<b>Subject:</b>  <b>MIL ON WITH DTC P2610</b>	<b>Bulletin No:</b> 01-001/13
	<b>Last Issued:</b> 09/25/2013

- This bulletin supersedes the previous bulletin 01-001/13, issued on 01/07/13 and 01/16/13. The APPLICABLE MODEL(S)/VINS and WARRANTY INFORMATION have been revised.
- Changes are noted below in Red beside the change bar.

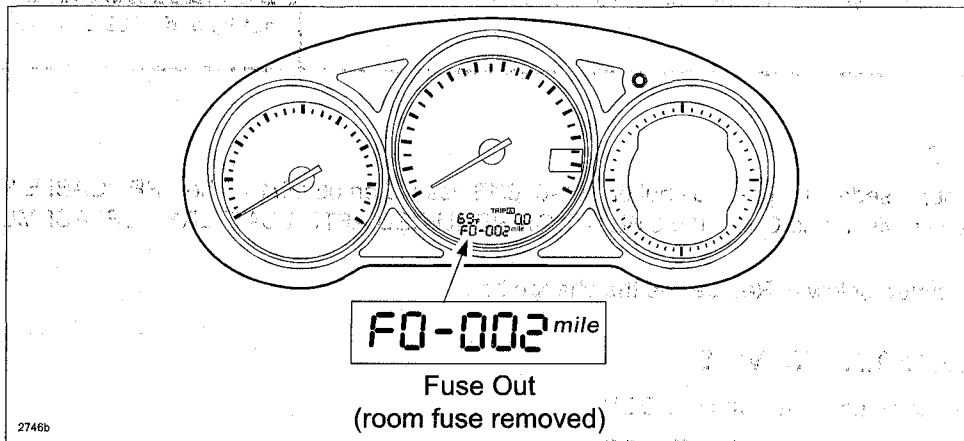
Some vehicles may experience MIL illumination with DTC P2610 (Instrument cluster internal engine off timer performance problem) stored in memory after engine start and room fuse 15A (A) removed.

**NOTE:** The odometer will display "F0-002" during transport mode (room fuse 15A removed). Transport mode is canceled when room fuse 15A is installed or the vehicle odometer is more than 12.4mi (20km).

1. Verify DTC P2610 is stored in PCM memory.
2. With the ignition off, install ROOM fuse 15A.
3. Clear DTC P2610 from PCM memory using IDS.
4. Verify no other DTCs are stored in memory. If so, troubleshoot them according to the MS3 online instructions or Workshop Manual.
